Technical Bulletin

No. ZB - 001

SUBJECT: Cutter Problem

ZB α

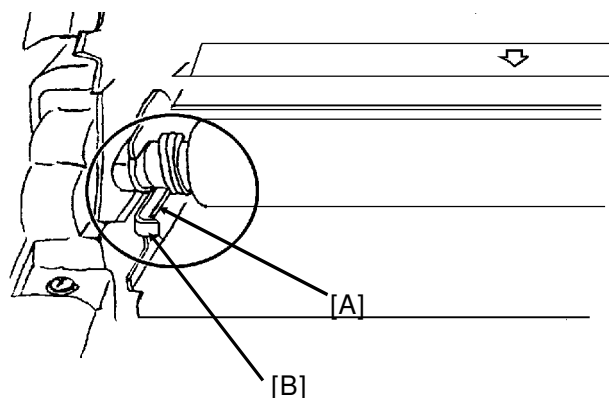
[Problem] The machine may not cut the paper in the correct position.

[Cause] The spring clutch was not lubricated enough.

[Action in the field] Lubricate around the spring clutch.

1. Open the printer cover on the brush.
2. Lubricate the spring clutch with grease (Mobil Tomp 78: P/N 54479078), turning the platen roller forward one rotation by hand.

Note: Do not apply grease to any parts other than the spring clutch. If you do, remove the grease immediately with alcohol.

3. Use alcohol to clean any parts of the platen roller that you touched.
4. Turn the platen roller back to the home position.
(The long end of the spring [A] should touch the under side of the rib [B] of the decurler as shown in the diagram.)

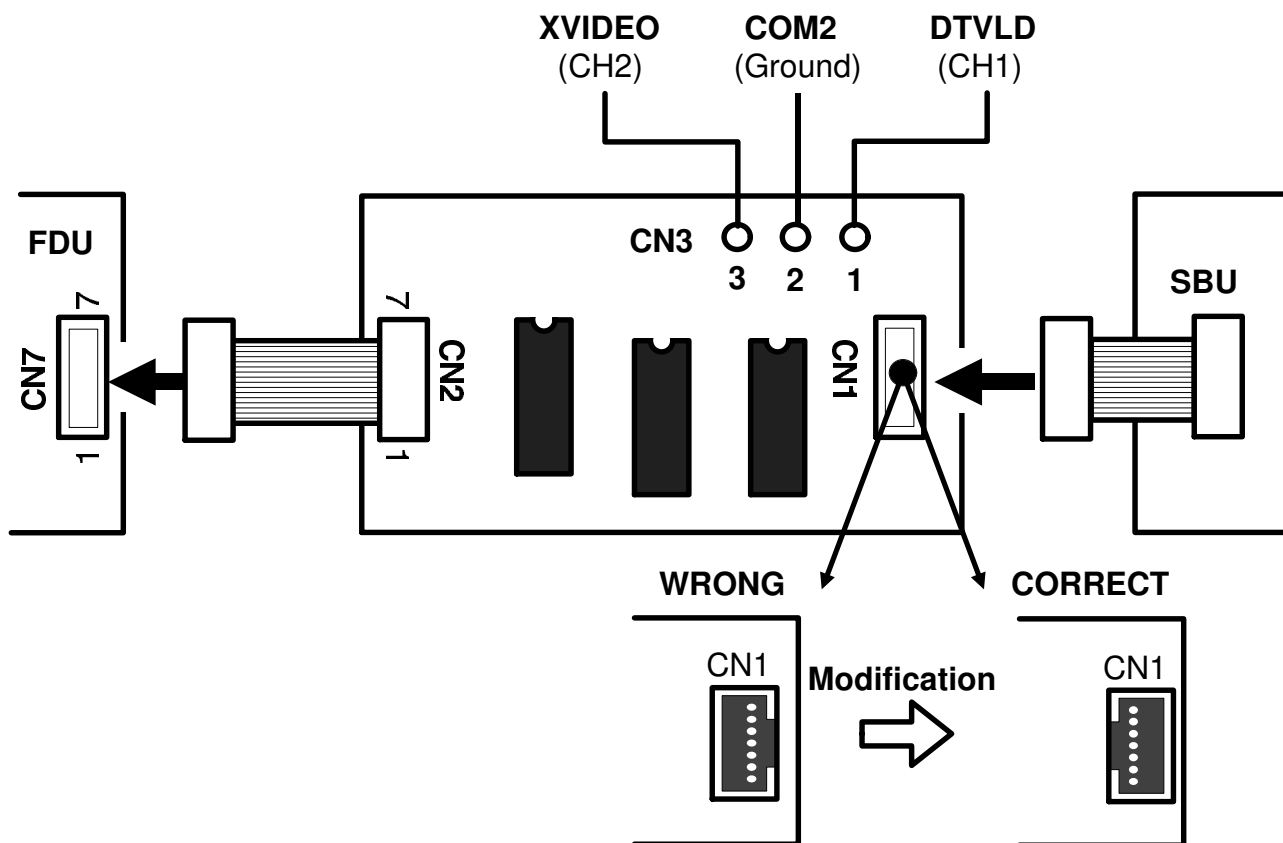
The PCB for scanner adjustment (P/#: H0939650) needs small modification as explained below.

The PCBs produced in early times that have white CN1 connector cannot generate the test signals, as the CN1 is installed in a wrong way.

If the color of CN1 is white, remove it from the PCB and install it correctly on the PCB.

If the color of CN1 is brown, the PCB can be used without modification.

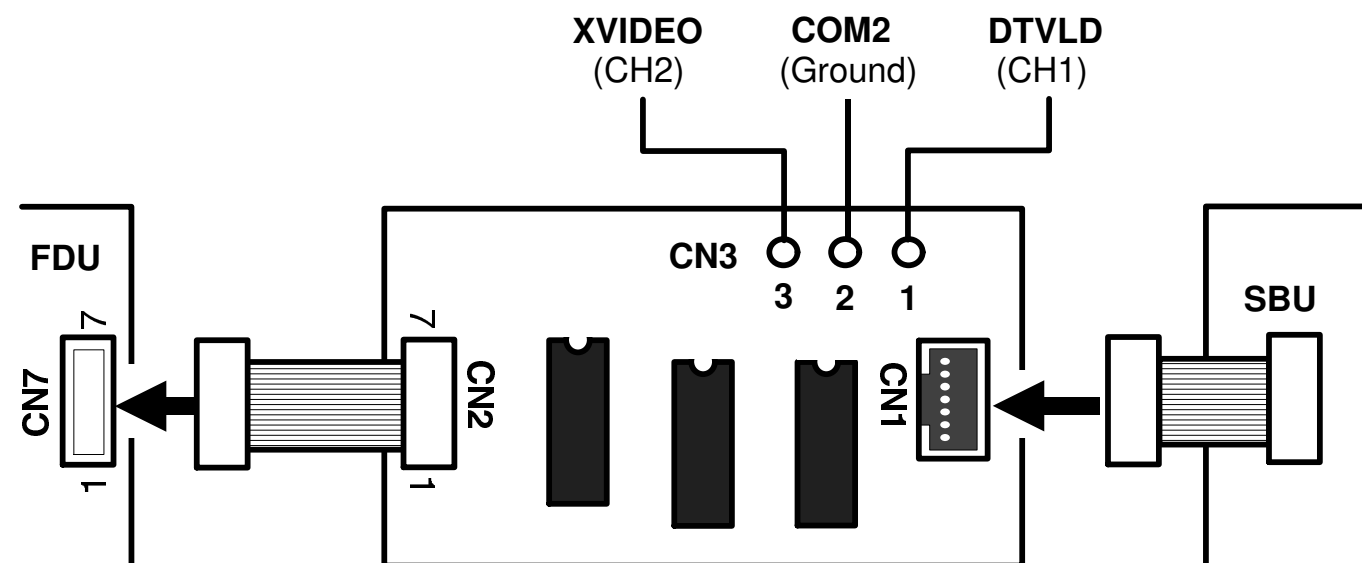
In the service manual section 4-5, the illustration to explain scanner test PCB (P/# H0939650) connection was wrong. **Actually, the PCB cannot be connected as in the illustration, but connecting the PCB as shown in the service manual may cause the SBU or FDU defective.**

So, please find below the illustration for correct PCB connection when adjusting the scanner.

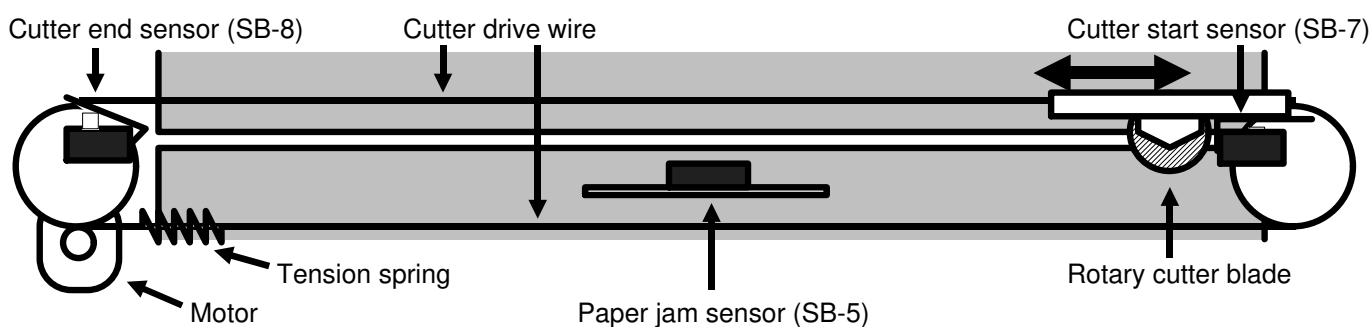
The machines with automatic paper cutter may indicate "REMOVE PRINTOUT / ADJUST FAX PAPER" on the LCD display frequently, and the cutter may not work correctly.

The cutter start position sensor (SB-7) and/or the cutter end position sensor (SB-8) is/are defective.

Replace whole cutter unit or defective sensor(s). The part number of the microswitch which is used as these sensors is;

H5022210

When replacing the cutter unit, remove the jam sensor (SB-5) from the old cutter, and install it on a new cutter unit.

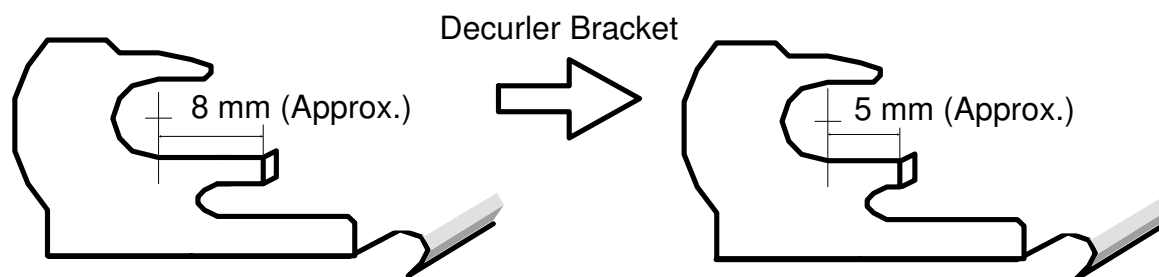
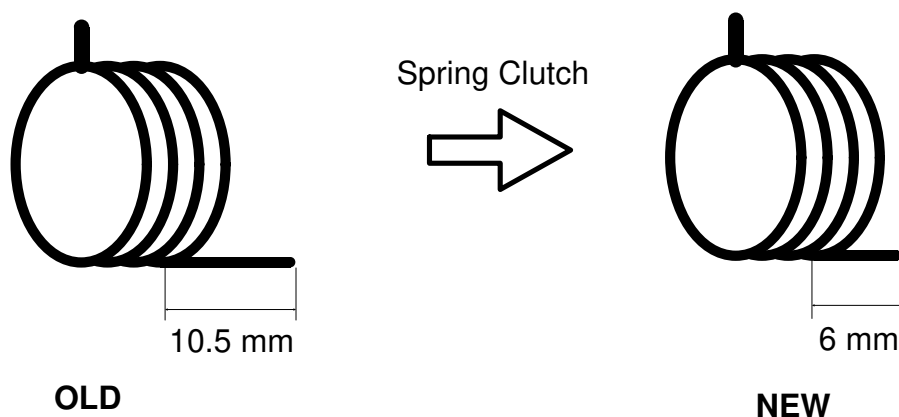
The thermal head surface might be scratched by the spring that is used as spring clutch for decurler.

The decurler bracket and the spring clutch have been modified as follows. Use the new parts as a set for future replacement.

Index	Old P/#	New P/#	Description	ICA
154	H5022112	H5022116	Decurler Bracket	X/O
114	H5022107	H5022117	Spring Clutch
